04V-609
(13 pages)

SUBJECT: Campaign #93 – Workhorse™ Fuel Line

INSTRUCTIONS TO PERFORM CAMPAIGN #93

Inspection of Fuel Line on 20,700 lb. GVWR or greater Workhorse Chassis

Photo shows top view of transmission on bare chassis for clarity of locations

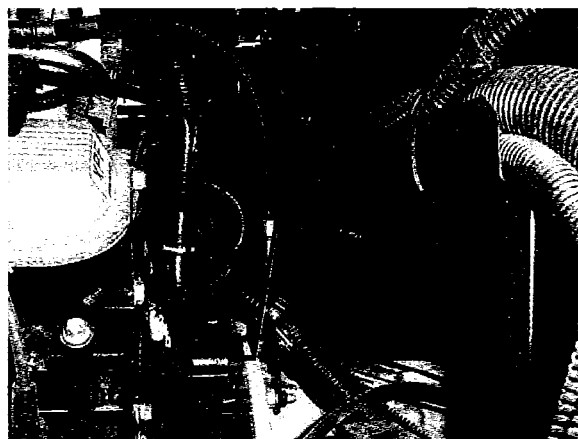
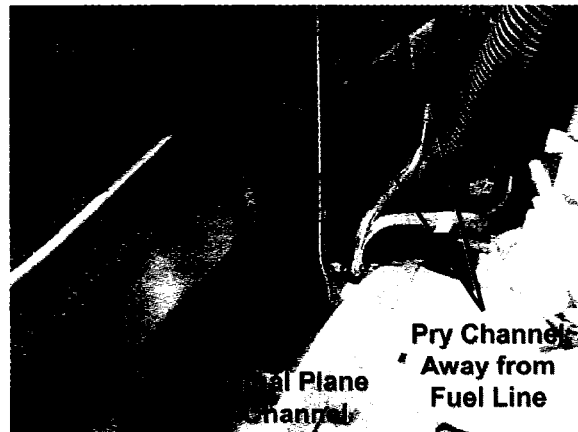
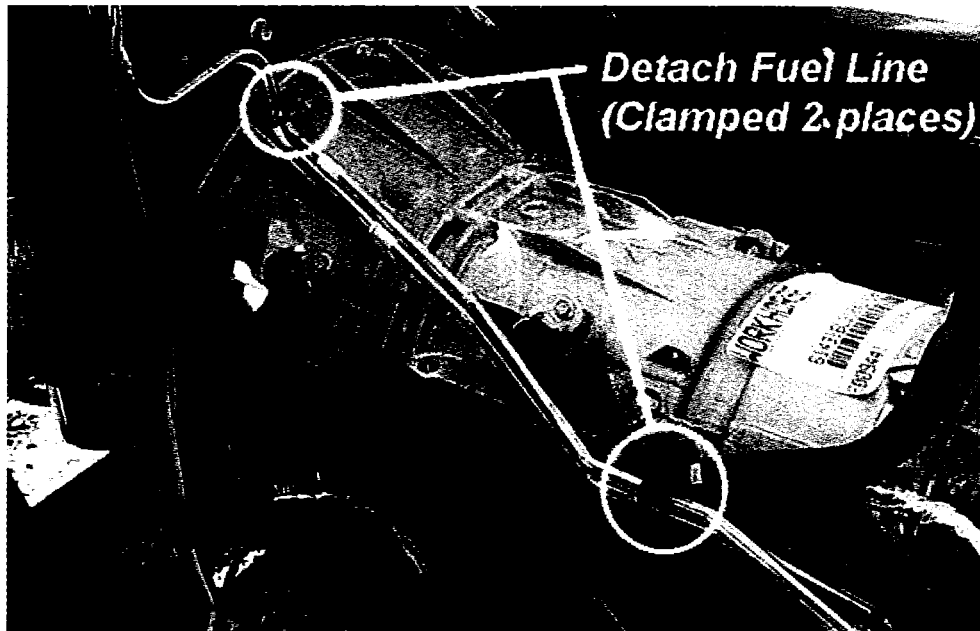
The basic procedure involves inspecting the fuel line and prying the wiring support channel back away from the line to provide additional clearance if necessary.

CAUTION: *If inspection reveals that the fuel line has any abrasion, wear or damage, the fuel line must be replaced.*

- Remove the engine cover and visually inspect the location of the wiring channel in relation to the fuel line. Also inspect the fuel line for signs of contact or damage.

- If the channel is closer than $\frac{1}{2}$ " from the fuel line, place a pry bar against the top flange of the transmission bell housing and pry the channel away from the fuel line as shown in the photos to provide $\frac{1}{2}$ " minimum clearance.
